# The Calcutta Gazette

WEDNESDAY, JULY 6, 1921.

### NOTICES TO MARINERS.

The following Notices are published for general information.

*Charts affected.*—No. 1725, Champion bay.

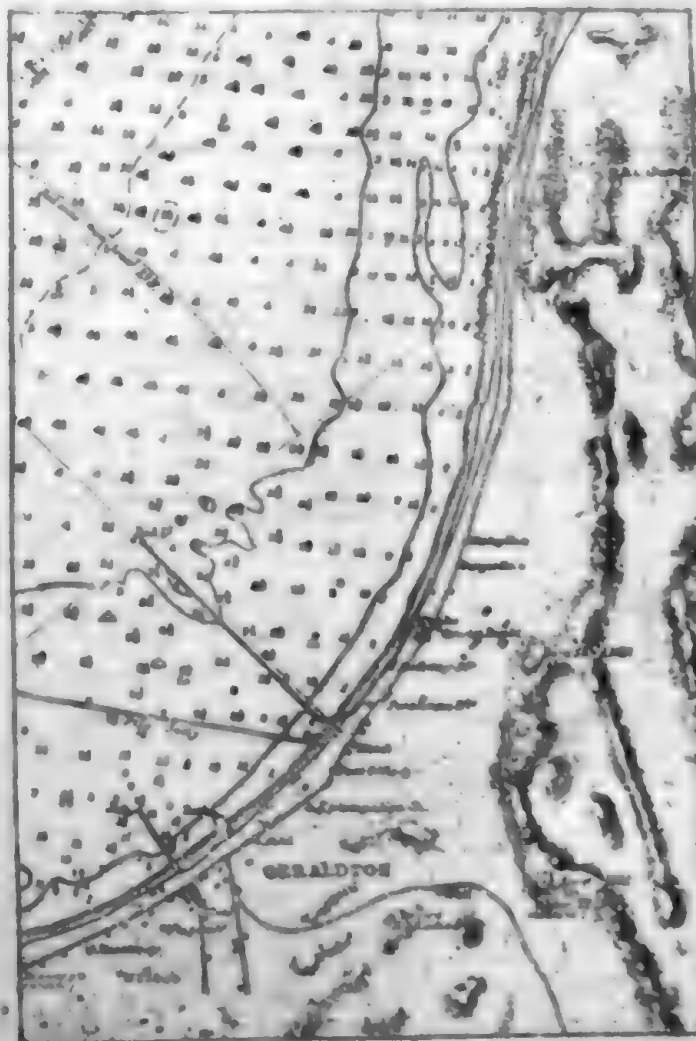
*Details.*—The accompanying reproductions of portions of charts Nos. 1725 and 1723 show the following:—

- (a) Amendments to charts with regard to shoals.
- (b) Extension of the North jetty and amended position of front leading light.
- (c) New pile jetty completed, from which a *green* light is exhibited.
- (d) Position of certain landmarks.
